Historic District Review Committee
Staff Report
Date of Meeting: September 12, 2011
CAPP2011-0012
Historic District: Goose Creek
Project Planner: Lauren Murphy

CAPP 2011-0016 David & Lisa Marvil: New Residential Construction. PIN #492-36-1990.

Figure 1: Subject Property, environmental characteristics

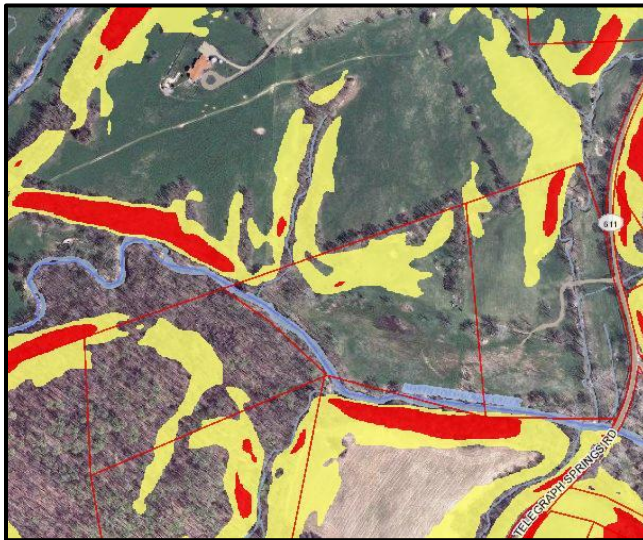
The Guidelines state that new construction should be sited according to historic precedents (Goose Creek Guidelines, *Guidelines for Site Elements, Siting*, page 39, Guideline 1). Farm houses were typically sited between two higher landforms, on a saddle of land, rather than on the ridge of a hill. The proposed house is sited on a small saddle of land, consistent with the Guidelines. The site is well shielded by the sloping topography of the subject parcel as well as surrounding sites. As with the

original CAPP2010-0021 approval, the proposed structure will not be visible

from Telegraph Springs Road and is located more than 1000 feet from the road. The house will be oriented to the south such that the woods will provide a visual backdrop and the front elevation will overlook the stream. **The siting of the house meets the Guidelines for the siting, placement and orientation of new construction.**
